# Expert Opinion Report - Rectification

10-12 View Point Road, McCrae

PSM5226-005R 11 June 2024

**Inset 3: CivilTest description of debris flow as “fill” (Document 9, pdf page 3)**

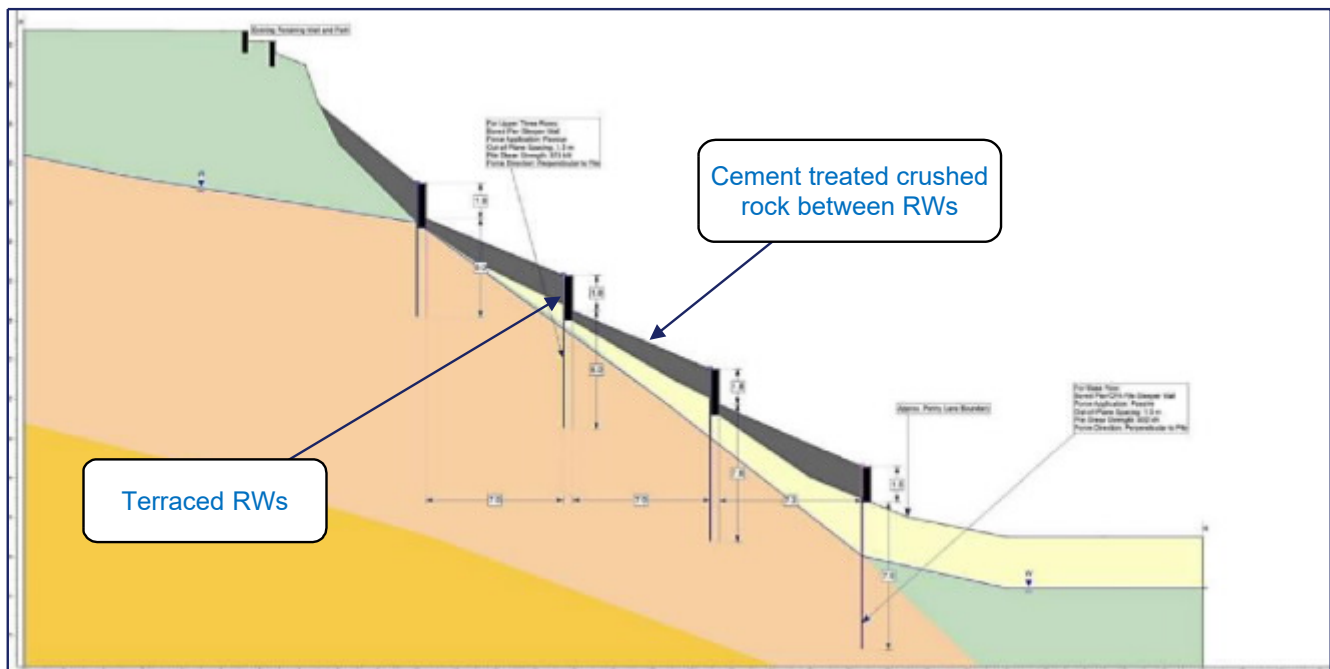
10. Documents 9 of the Brief is the CivilTest Land Stability Assessment report 1222044-3 (24 March 2023). The report indicates to me:
- (a) Boreholes drilled at the toe of the slope in Penny Lane encountered landslide debris, Inset 3 (Section 2.1, pdf page 3).

- (b) Boreholes 1 and 2 encountered landslide debris 1.2 m and 0.7 m thick respectively (Appendix C, pdf pages 29 to 30). I have assumed that all fill reported at the toe of the slope is landslide debris.

**Inset 4:** CivilTest section with proposed RW remediation (Document 12, pdf page 29). I have added my commentary in blue.

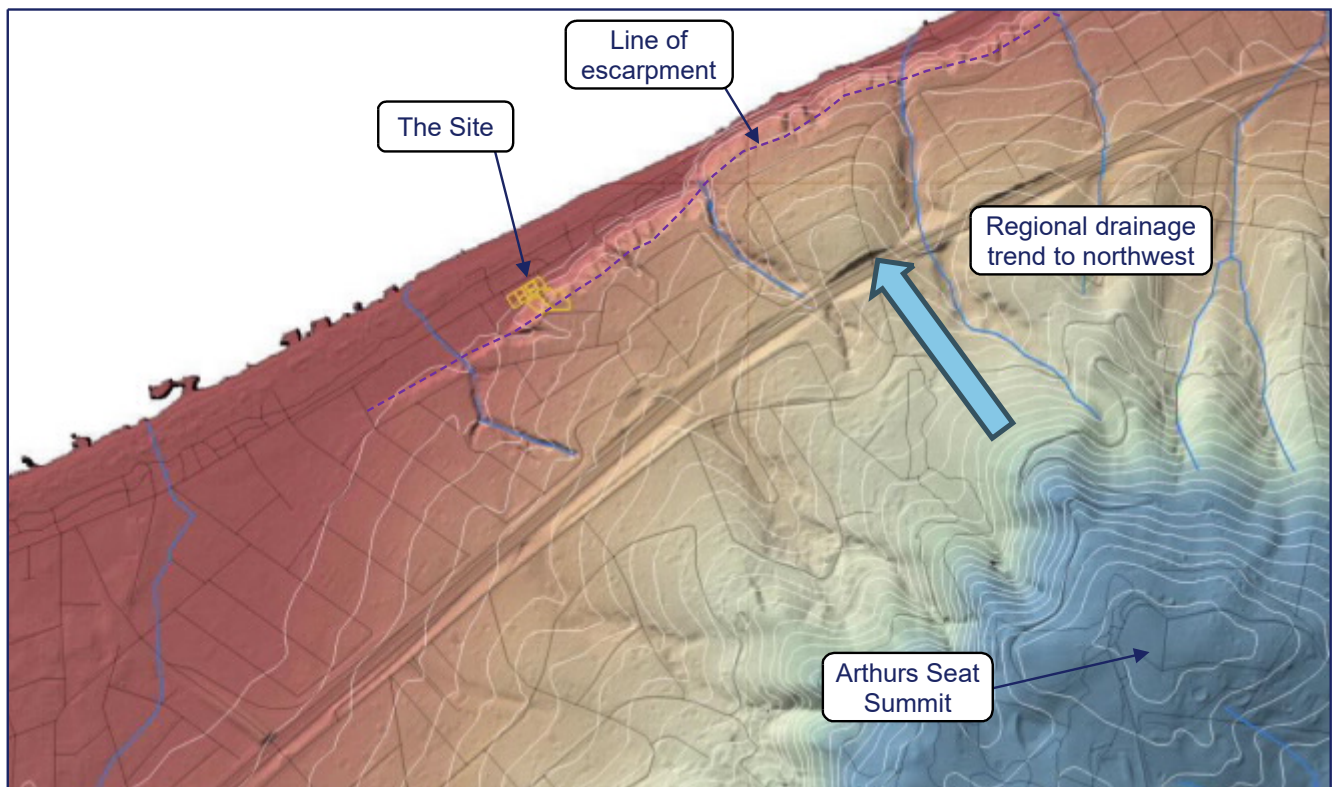
- (a) Section 6.4 (pdf page 11) describes the proposed “Slope Stabilisation System” to remediate the Landslide and includes:
    - i. Four rows of retaining walls (RWs).

- ii. Cement treated crushed rock (CTCR) placed between retaining walls with a maximum 22 degree slope angle.
    - iii. “Loose colluvium/landslip material should be removed from the slope”.

- (b) Appendix E (pdf page 29) illustrates the proposed remedial works in section view, Inset 4.
